PRODUCT IMPROVEMENT

RPB, RPA and RPC Commercial Two Speed Coolers

WALL SWITCH

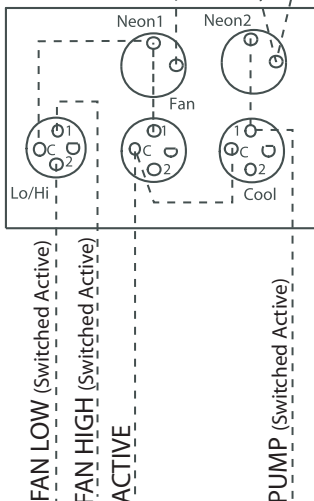
Due to pending changes in some state safety regulations, as well as energy management becoming increasingly important to all Australian business Braemar Commercial 2 speed wall switches will now come standard with 2 Green Neon Indicators.

The individual neon's on the wall switch will illuminate to indicate when either the pump (cool) or the fan motor (fan) has been switched on. This will allow office and factory personnel to identify at a glance if the Coolers fan or pump are running.

All coolers manufactured from Serial Number C0902xxxx will have the new wall switch included.

Required wiring from the cooler control box to the wall switch.

- Active x 1
- Switched Active x 3
- Neutral x 1

New Wire Required

3 PHASE WIRING DIAGRAM

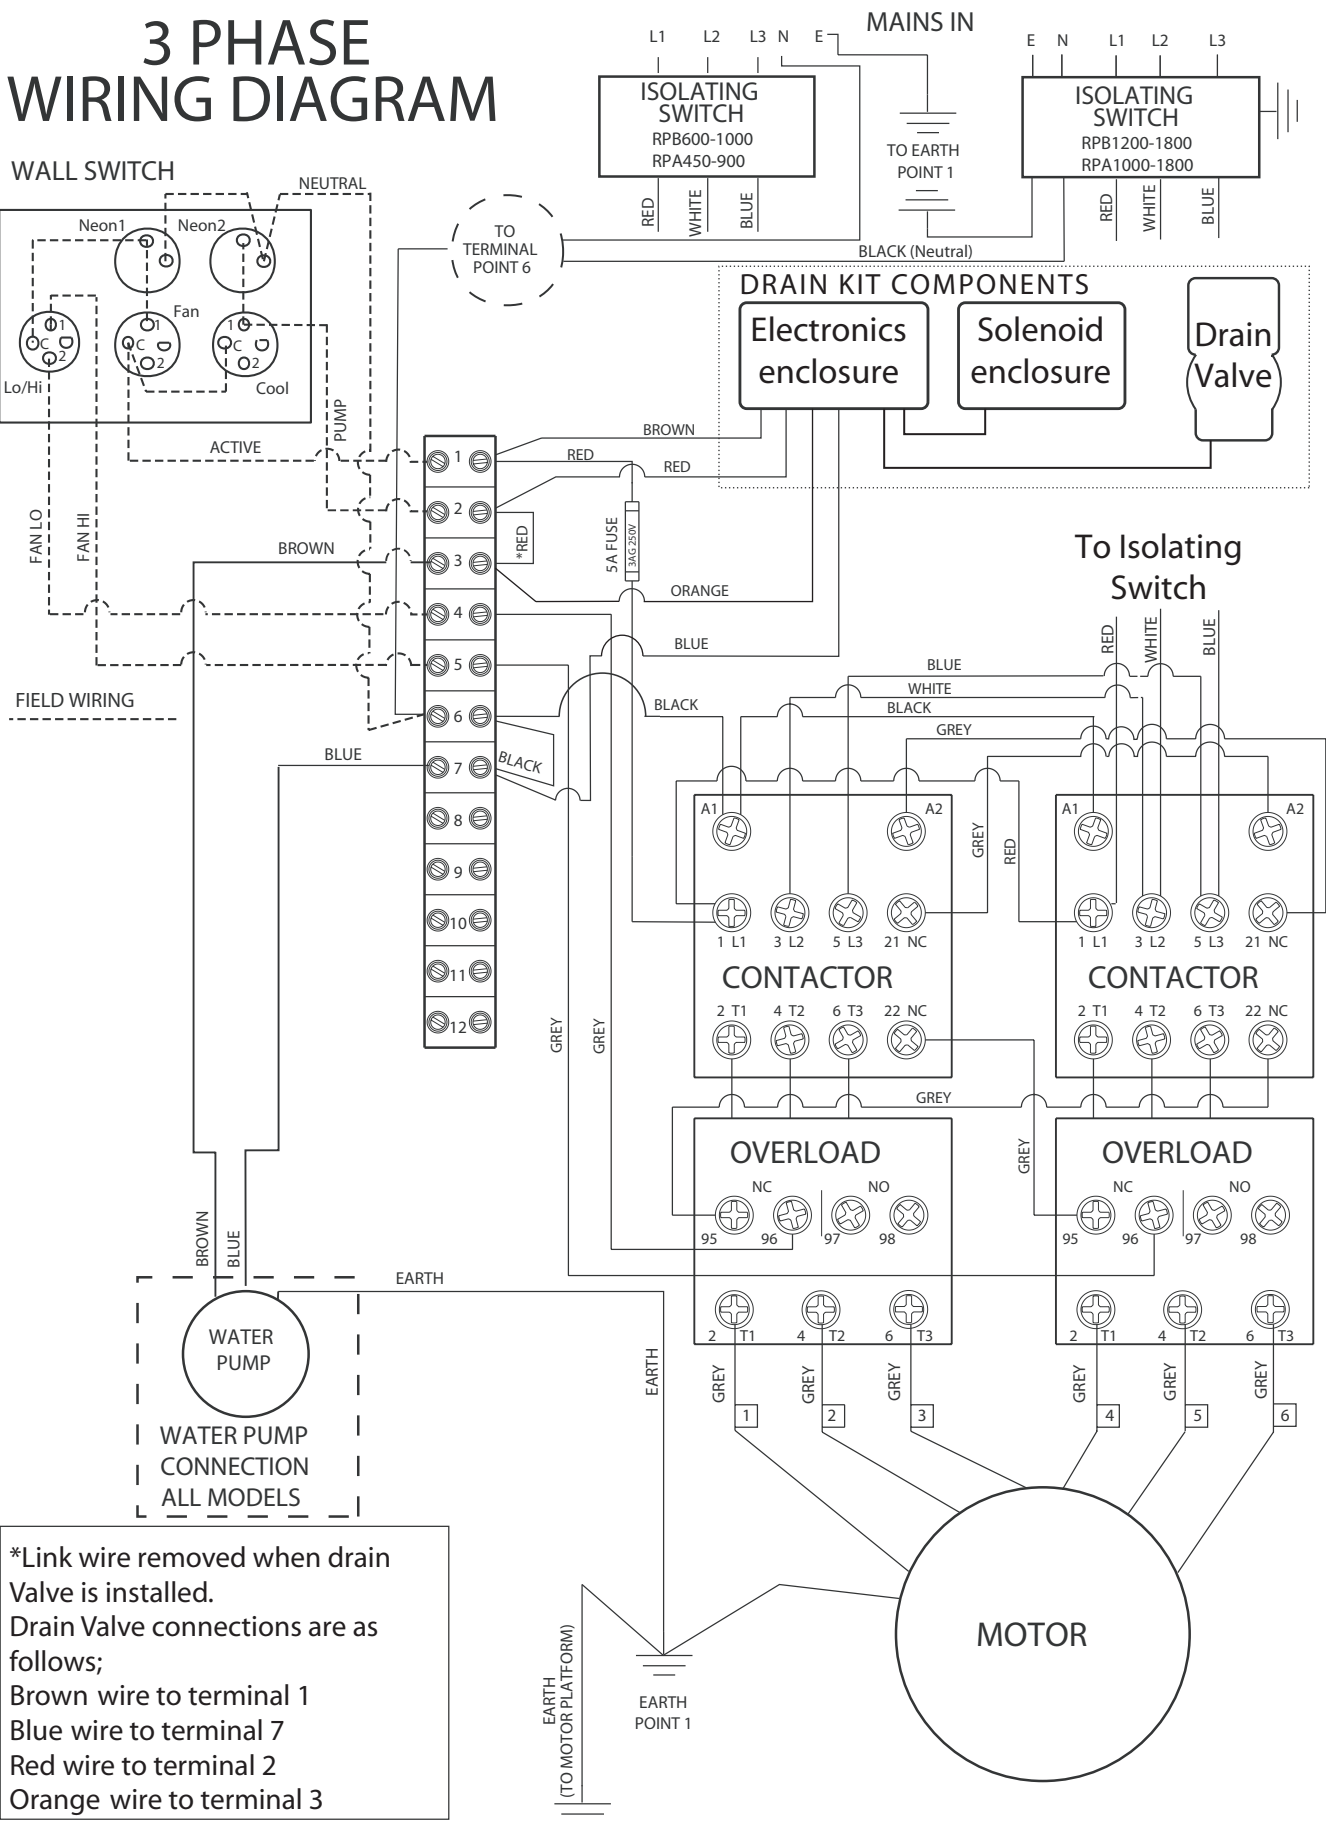
**THESE WIRING INSTRUCTIONS FOR UNITS MADE FROM MARCH 2009
AFTER THE INTRODUCTION OF NEON INDICATORS**

*Link wire removed when drain Valve is installed.
Drain Valve connections are as follows;
Brown wire to terminal 1
Blue wire to terminal 7
Red wire to terminal 2
Orange wire to terminal 3
